Regarding: 08V-461

RECALL

2007 XC50W (Vino Classic); 2007 XF50W (C³) Scooters FACTORY MODIFICATION CAMPAIGN – Connecting Rod

IDENTIFICATION PROCEDURE

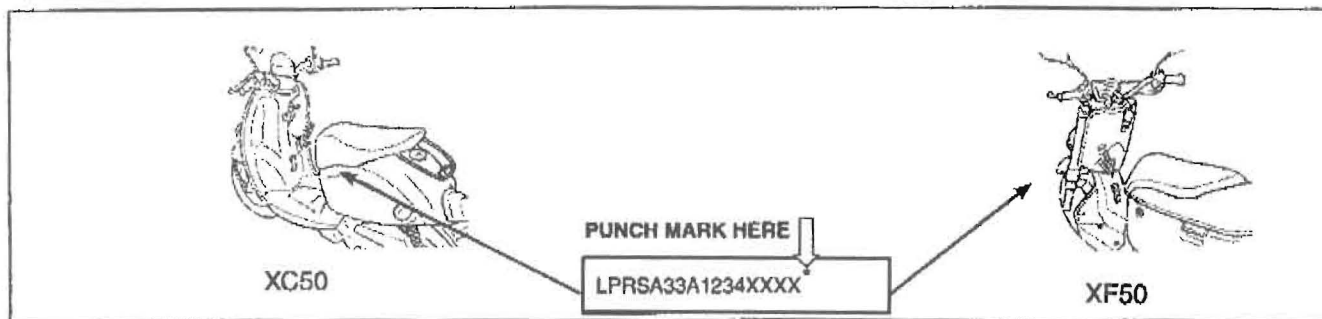
When the modification is complete, put a punch mark next to the Primary ID as shown. Check for this punch mark if you encounter an unfamiliar unit. You can also check unit status on YDS or by contacting your Regional Technical Advisor.
